Superfund Record of Decision (EPA Region 4)
Powersville Landfill, Georgia
(First Remedial Action), September 1987

EPA/ROD/R04-87/029
September 1987

3. SUMMARY OF PUBLIC COMMENTS DURING PUBLIC COMMENT PERIOD AND AGENCY RESPONSES

FIGURE 4

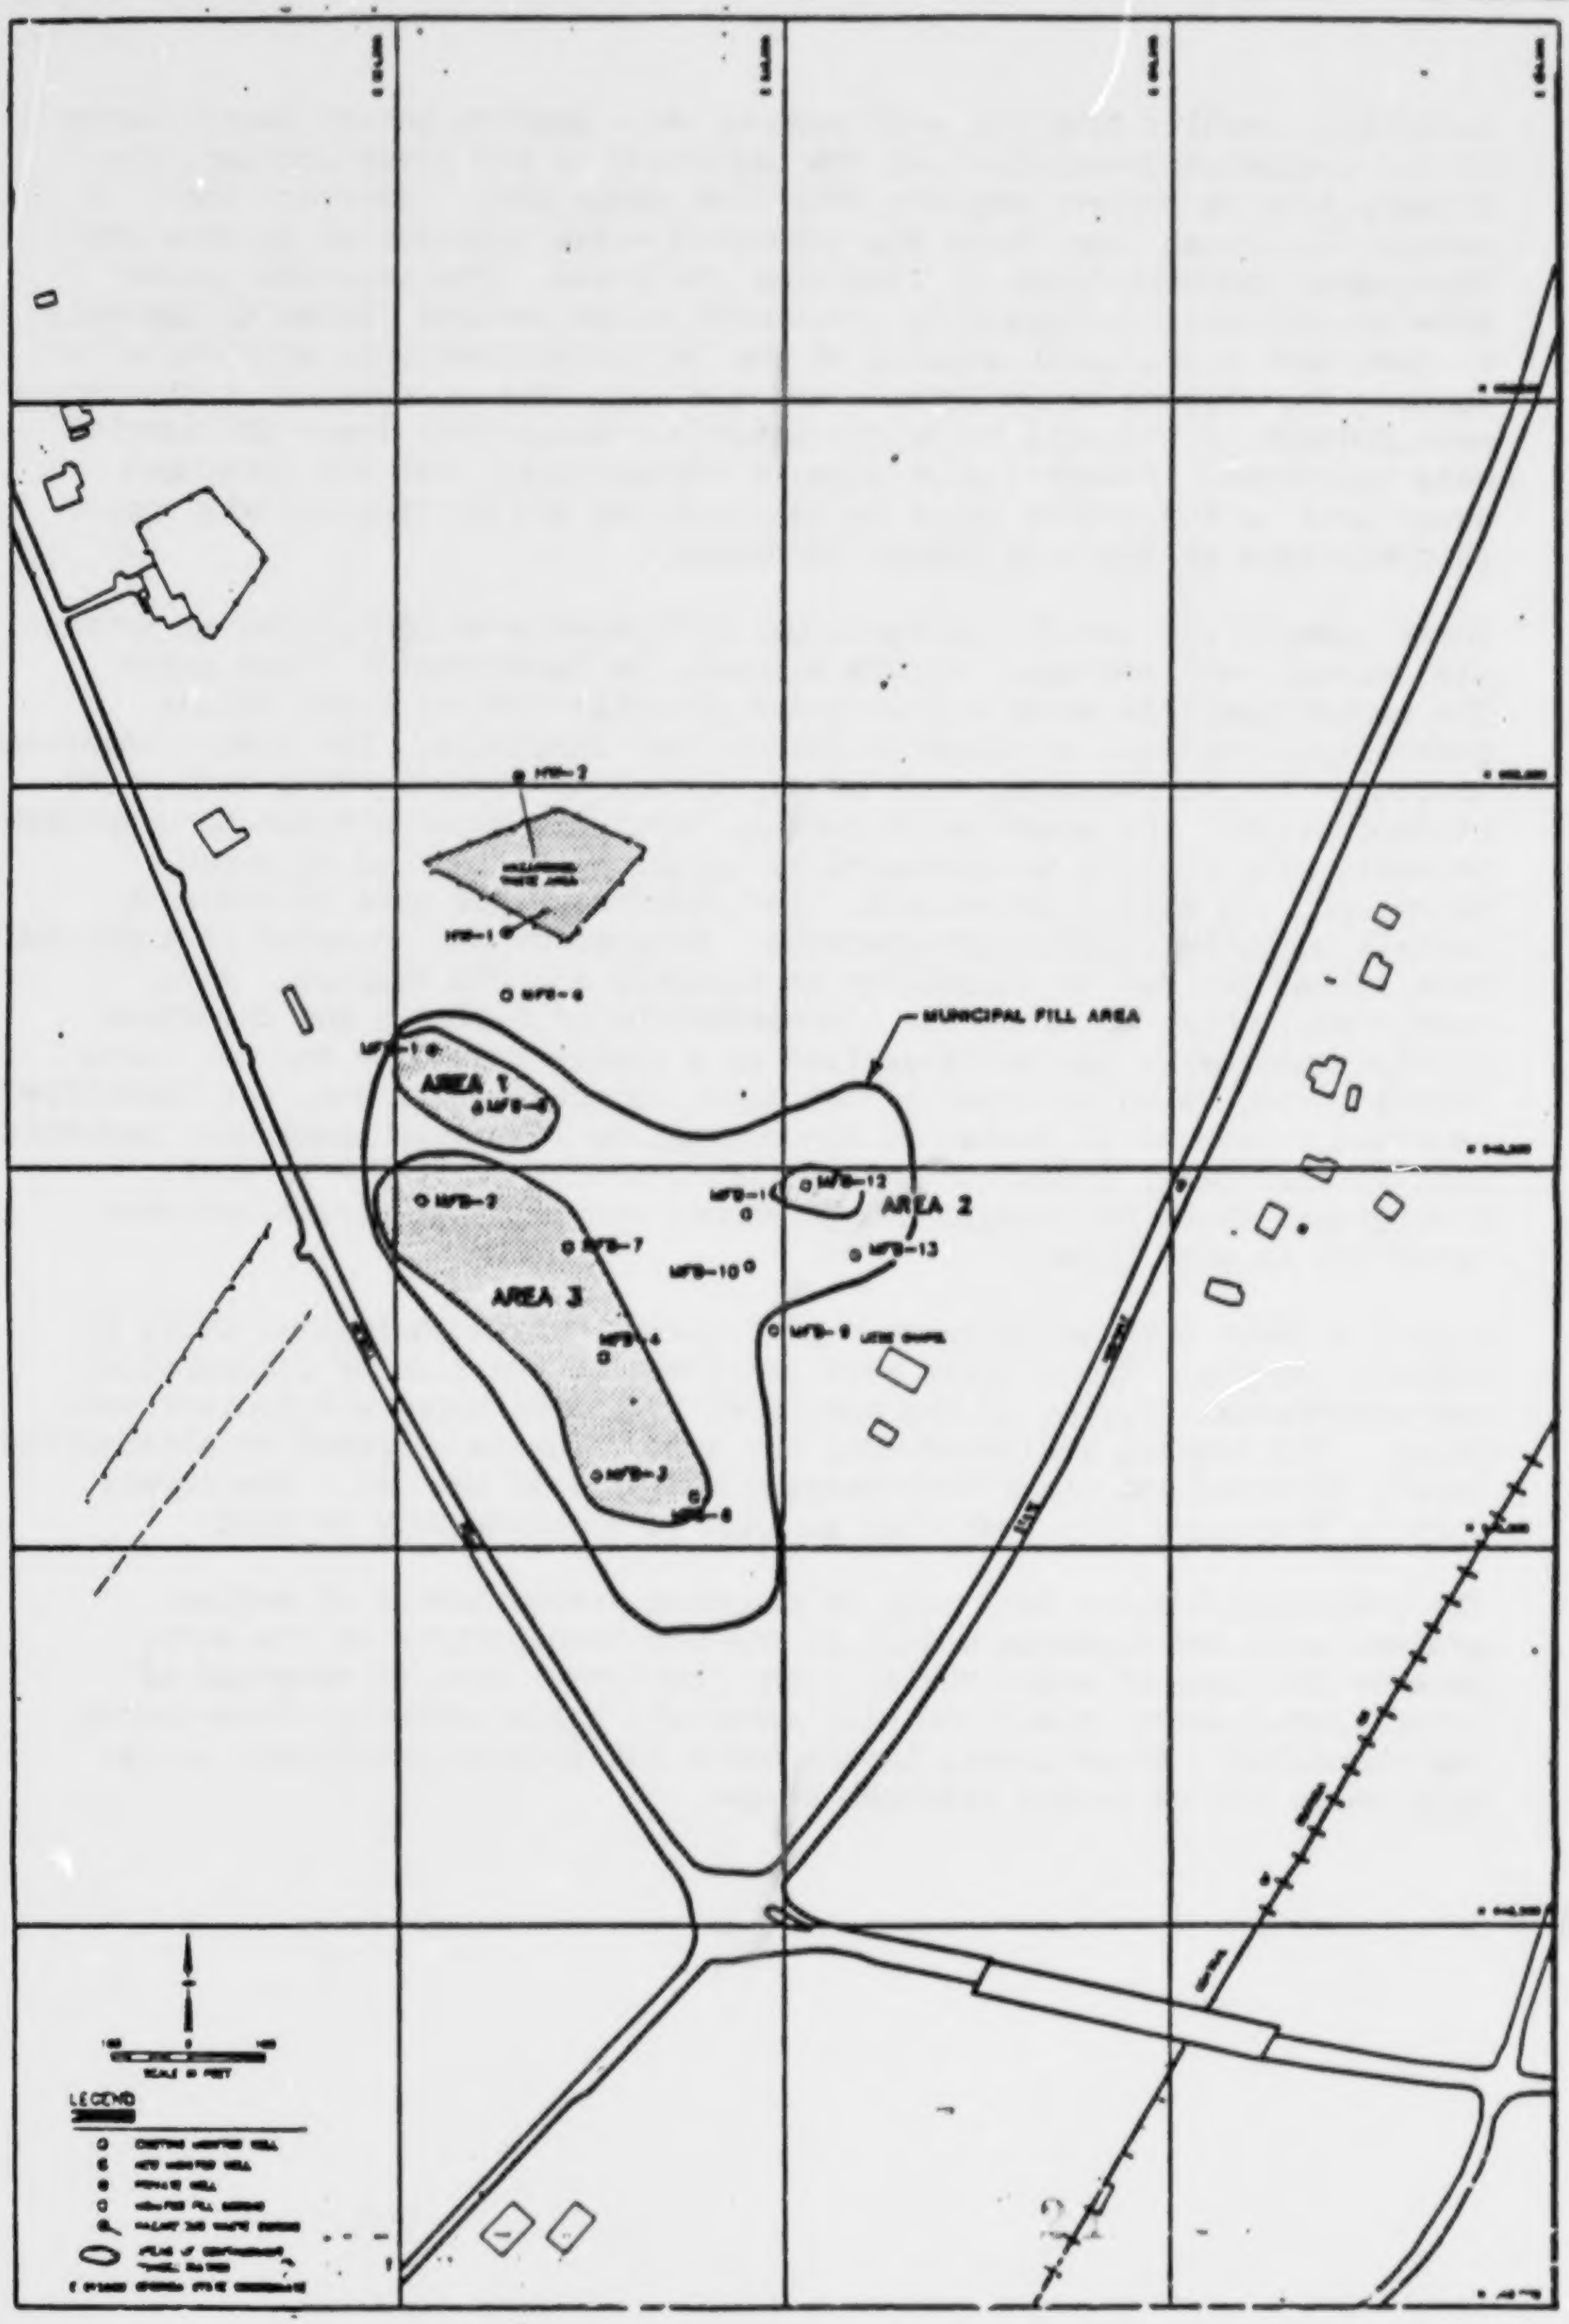
Comment: On Page 5-8, the Report refers to the fact that photographs taken by Georgia EPD personnel confirm pesticide disposal in Area 3 of the municipal landfill. It is not clear how photographs can actually confirm that "pesticides" were in fact disposed of at this site? Will these photographs be included in the Appendix of the final Report to document this conclusion?

Comment: On Page 5-8, the Report describes the conclusions reached regarding three contaminated areas of the municipal landfill. Considering the fact that the landfill was uncontrolled and open to all county citizens and business, the placement of any wastes would have been haphazard at best. The method of delineating the three contaminated areas is unconvincing and inconclusive. The manner in which these conclusions were reached should be clarified.

EPA response: We believe that the photographs, coupled with information in EPA and EPD files, support the statement. The photographs are in EPA records but will not be included in the report.

EPA response: Please note that the report indentifies these three areas as potential contaminant sources. Bearing that in mind, the conclusions reached and the methods used to reach those conclusions are adequate.
